NOTICE OF DECISION

DECISION OF THE PLANNING ADMINISTRATOR

CLASS 3 SITE PLAN REVIEW / CLASS 2 ADJUSTMENT CASE NO.: SPR-ADJ21-25

SUMMARY: A ~~189-unit~~ 201-unit multi-family development with an office/recreation building and pool.

9 BUILDING ~~#8~~ REAR ELEVATION FACING LA JOLLA DR NW

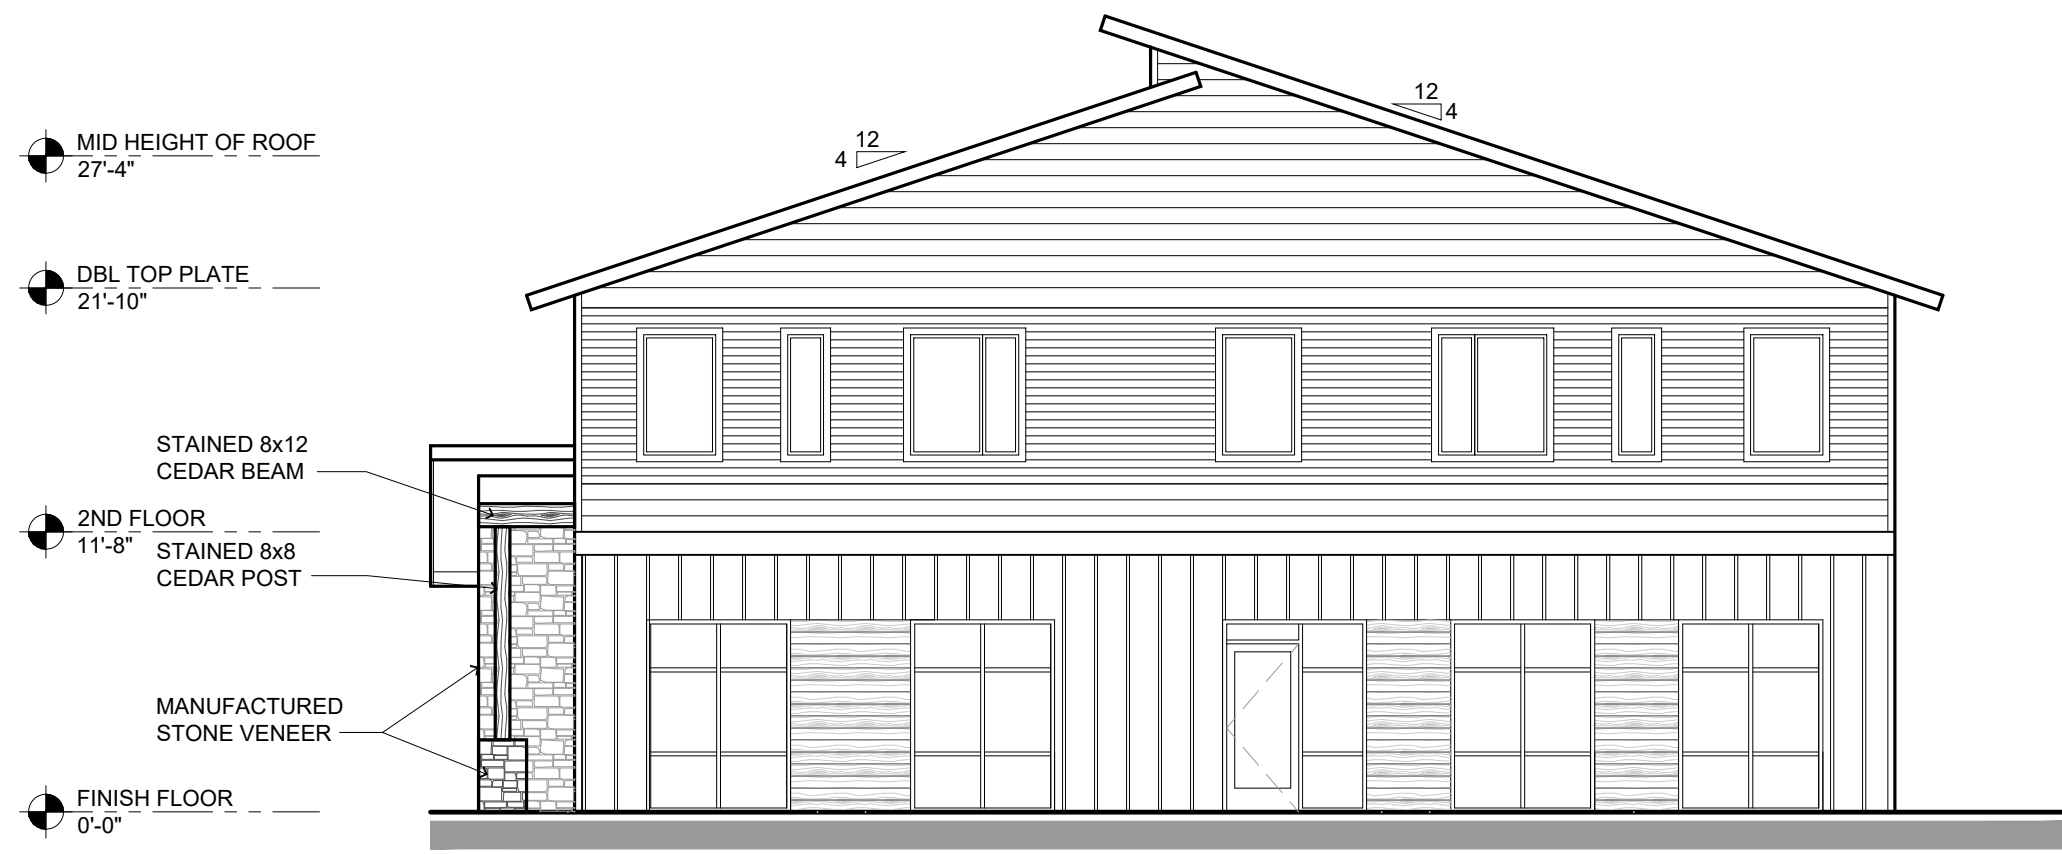
NW. However, the revised elevations for Building 1 in **Attachment F** do not confirm the 10-foot ceiling height and are not drawn to scale. The following condition is required to ensure that the proposal meets the standard:

- Condition 8:** Submit revised elevation drawings and plans for Building 1 at building permit to confirm a minimum height of 10 feet for the ground floor on Wallace Road NW.
